Product Change Notice

PCN#: EE-PCN24015

Outer sleeve printing design change on both TV and TVA series. Affected PNs are included in below table.

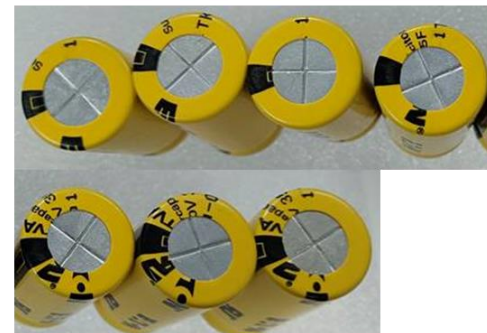
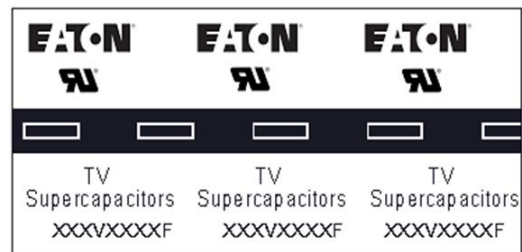
Move all text printing to be same half side of top view with polarity line. Same change is applied to both TV and TVA series but just different series name only.

Achieve better and consistent top view polarity indication for AOI detection.
